Early Site Permit (ESP) Application for the Clinton ESP Site
Docket No. 52-007

Subject: Responses to Supplemental Draft Safety Evaluation Report (DSER) Items

Re: Letter, U.S. Nuclear Regulatory Commission (W. D. Beckner) to Exelon
Generation Company, LLC, (M. Kray), dated August 26, 2005,
Supplemental Draft Safety Evaluation Report for the Exelon Early Site
Permit Application

This letter provides response(s) to the following draft safety evaluation report (DSER) Supplement Open Items.

Figure 2.5.2-5-2: Cumulative distribution of ASCE Method FOSIDs for components, compared to Existing Plant SCDF (From Ref. 3)

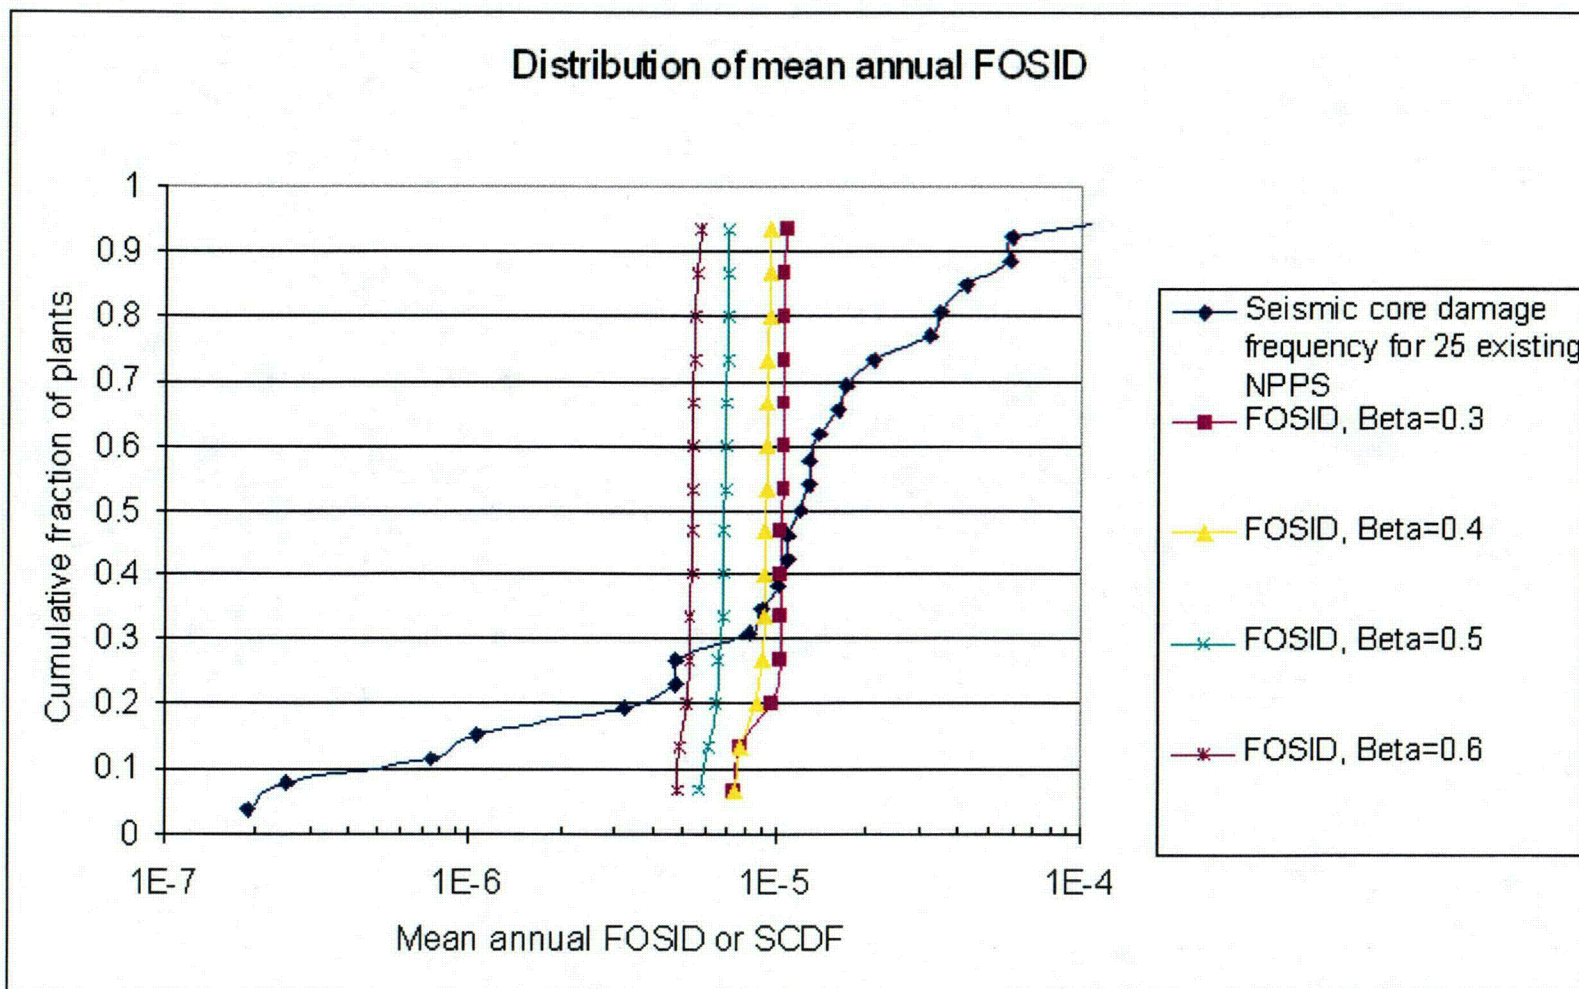
The results shown in Figure 2.5.2-5-2 are summarized as follows:

Figure 2.5.2-5-3: Cumulative distribution of ASCE Method SCDF, compared to Existing Plant SCDF (From Ref. 3)

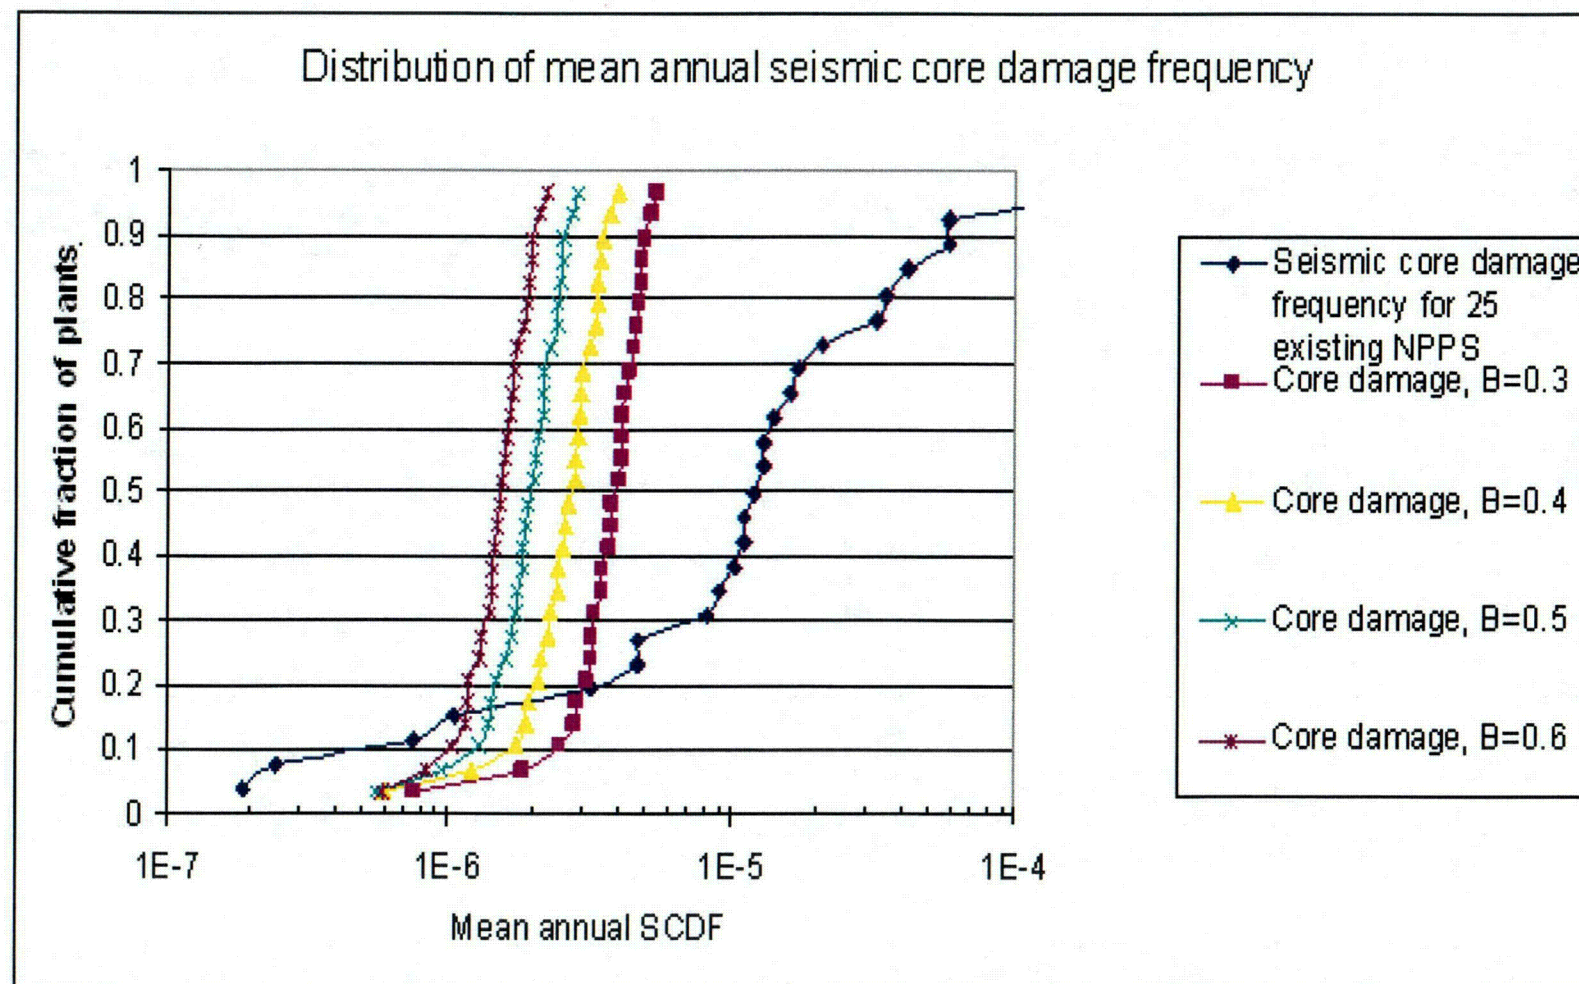
Under these same assumptions, SCDF were also computed in Ref. 3 for the 28 CEUS sites considered therein. The SCDF results for these 28 sites are shown in Figure 2.5.2-5-3 taken from Ref. 3. The results shown in Figure 2.5.2-5-3 are summarized as follows:
